P 61 094 SUPERSEDED BY P 61 118

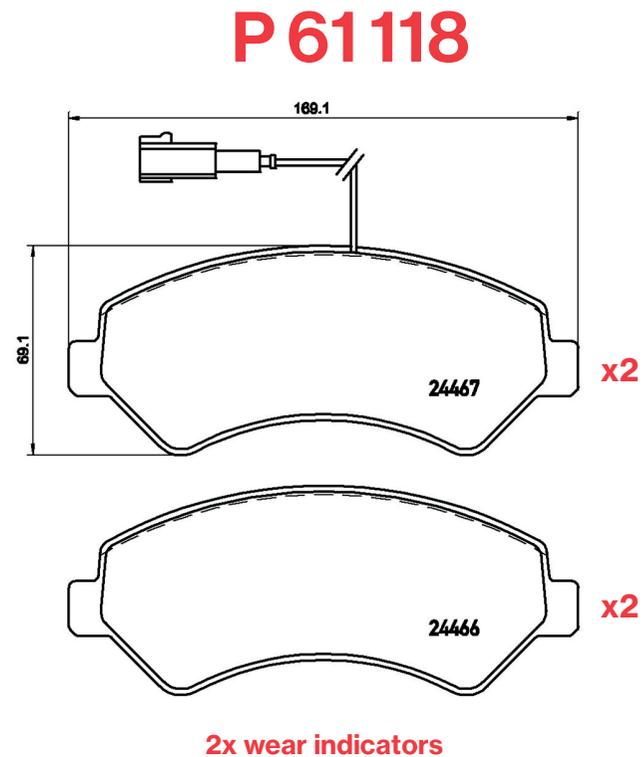
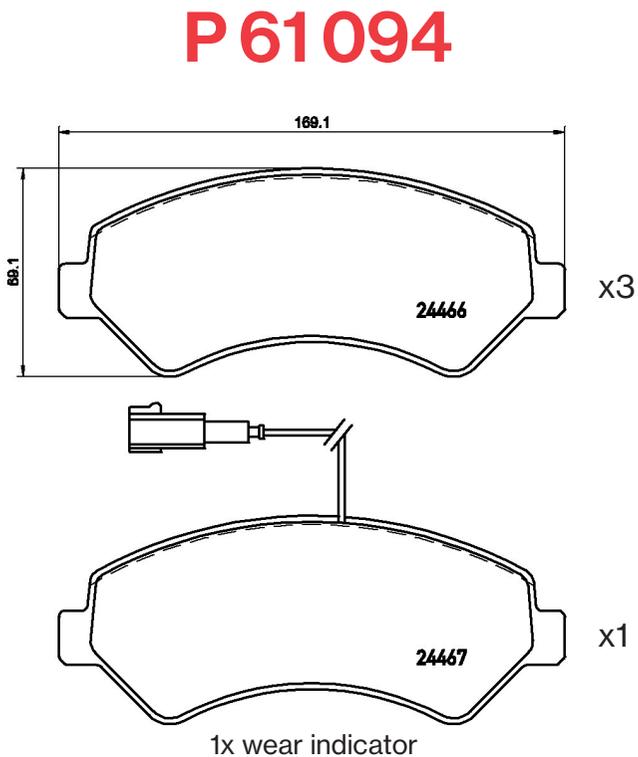
For the references P 61 094, Fiat changed the corresponding OES references from one wear indicator to two wear indicators per set. Wear indicators that are not used have to be simply cut off during assembly. Brembo will perform the same change, according to the OES programme. P 61 094 will be replaced by P 61 118.

Existing stock of P 61 094 can be sold out. Please consider that P 61 094 can be used only on vehicles equipped with one wear indicator.
